CITY OF SAINT PAUL
HERITAGE PRESERVATION COMMISSION STAFF REPORT

FILE NAME: 247 East Fourth Street
DATE OF APPLICATION: April 5, 2016
APPLICANT: Kaas Wilson Architects, Ryan DuPuis
OWNER: VoR Development
HPC SITE/DISTRICT: Lowertown Heritage Preservation District
CATEGORY: Rehabilitation
CLASSIFICATION: Contributing
STAFF INVESTIGATION AND REPORT: Bill Dermody
DATE: April 21, 2016

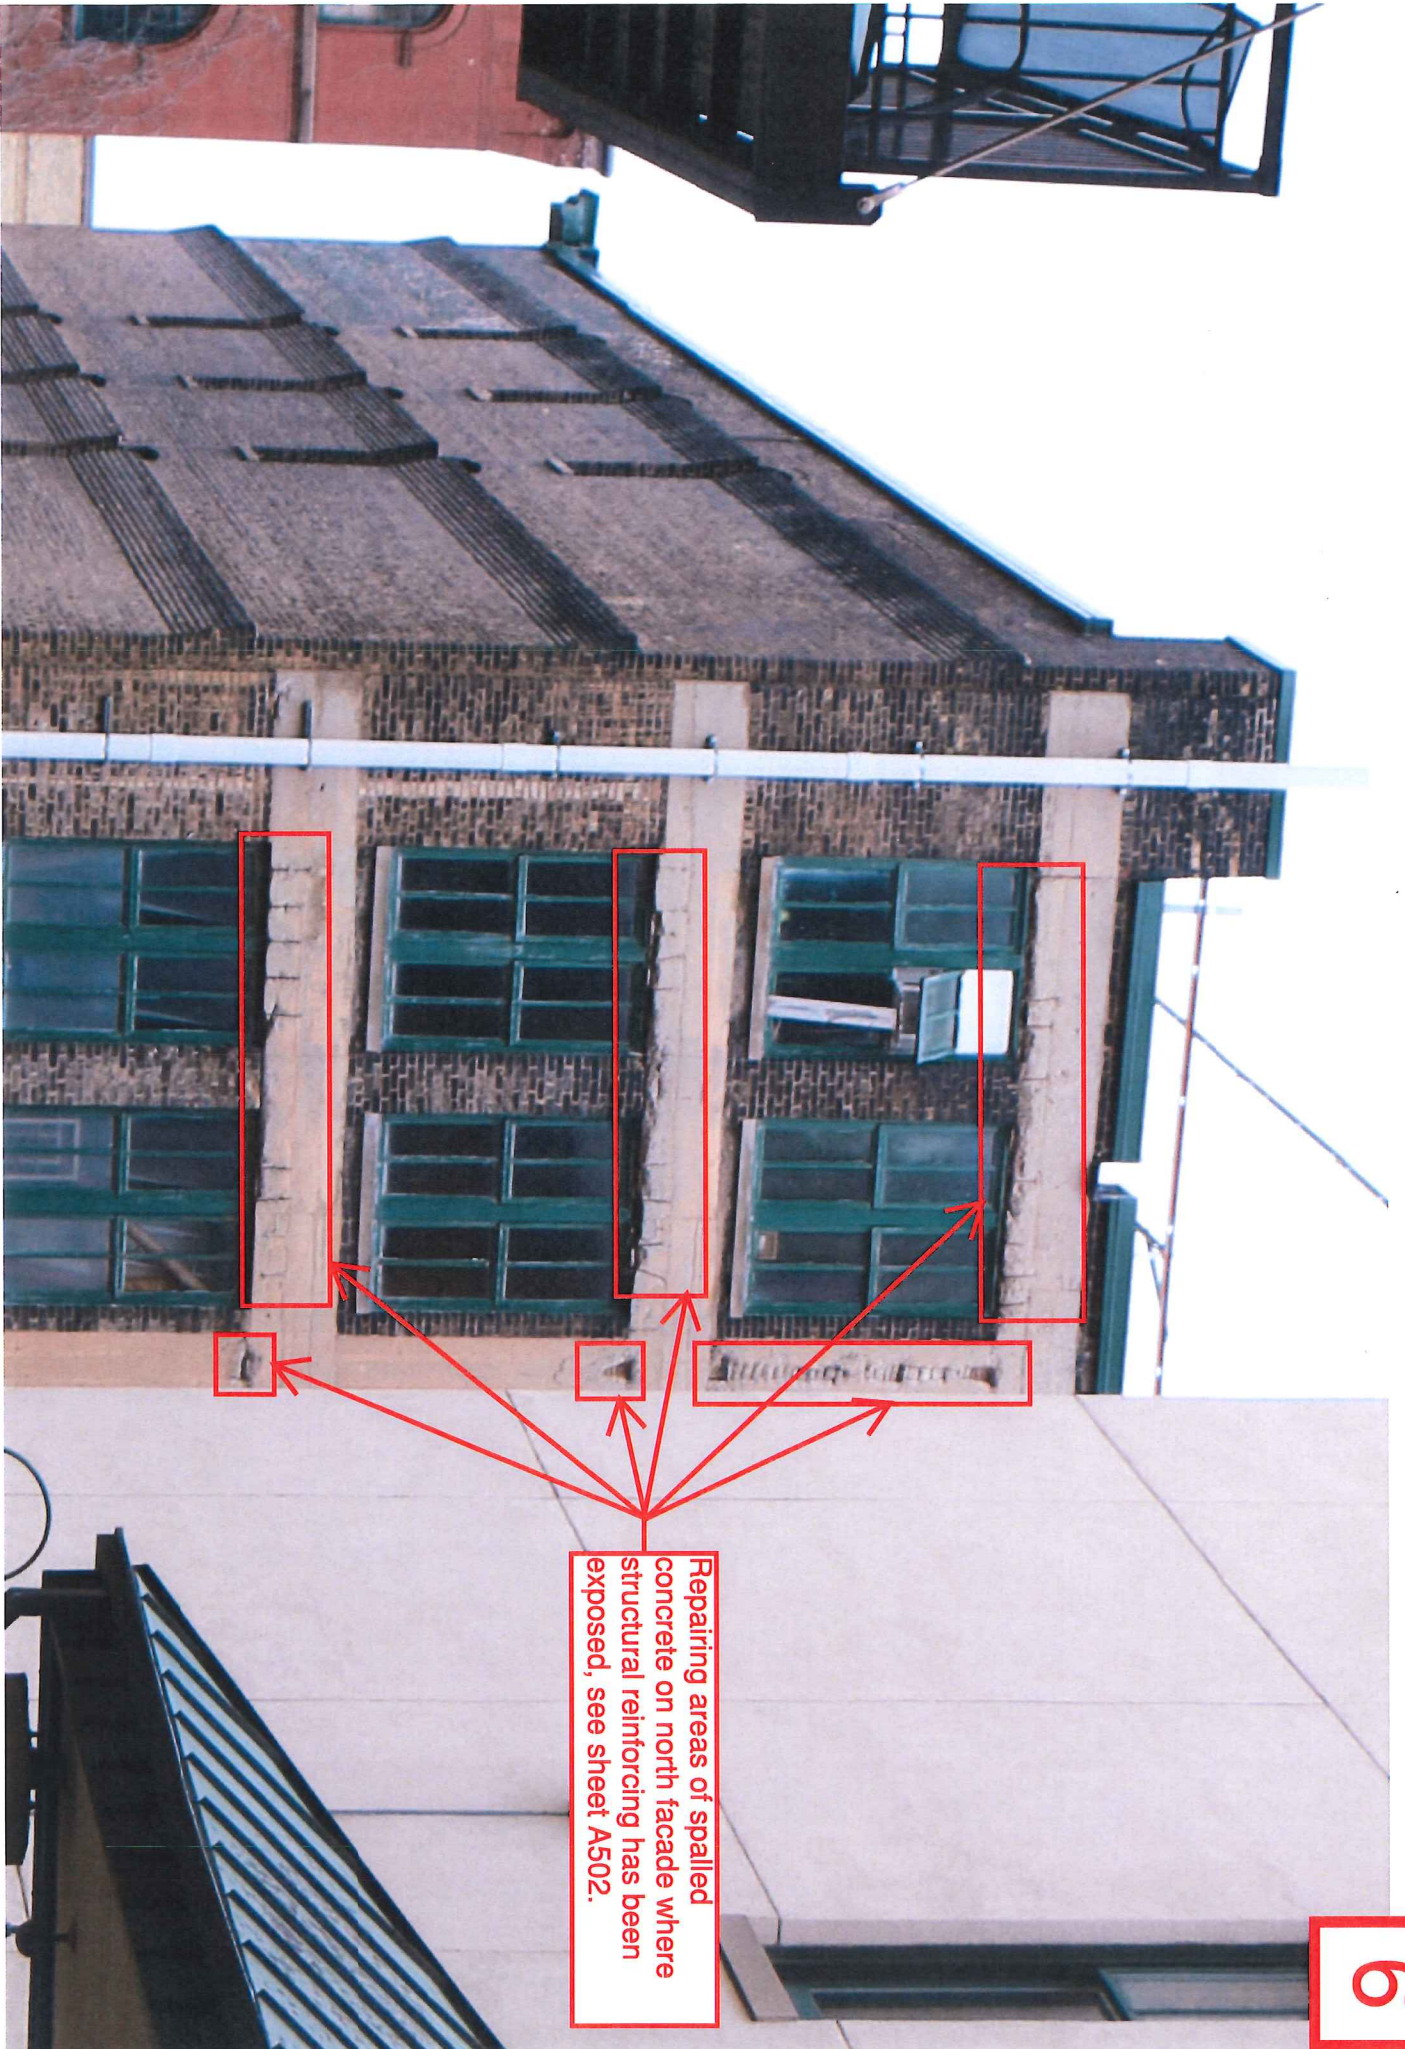
Repairing areas of spalled concrete on north facade where structural reinforcing has been exposed, see sheet A502.

Refurbishing existing steel windows to remain, see sheets A502 and A840. (Typical, all windows on this facade.)

Adding metal stair to loading dock
on north facade for egress, see
sheets A315 and A502.

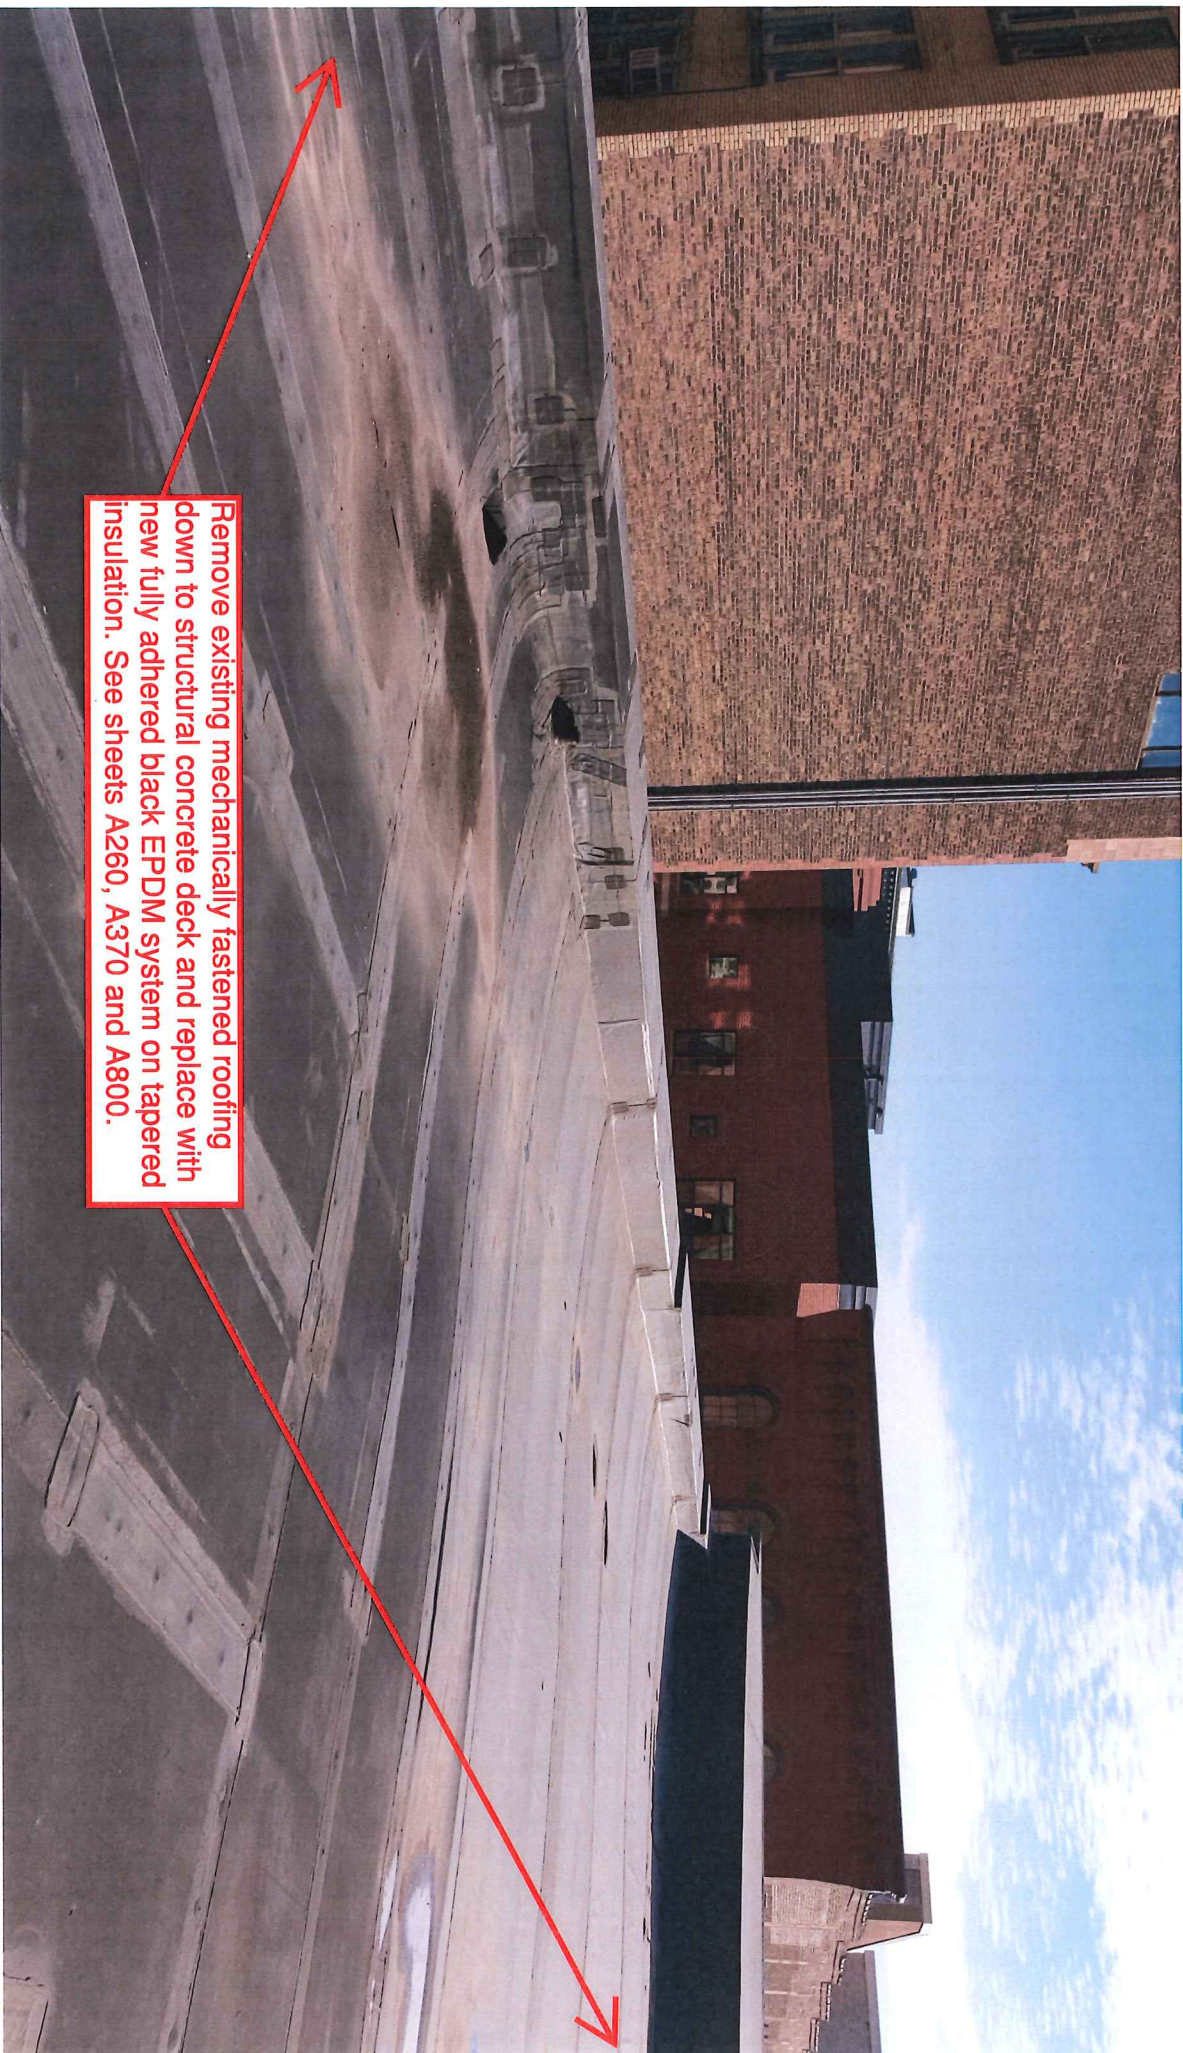
Repairing areas of spalled concrete on north facade where structural reinforcing has been exposed, see sheet A502.

Remove existing mechanically fastened roofing down to structural concrete deck and replace with new fully adhered black EPDM system on tapered insulation. See sheets A260, A370 and A800.
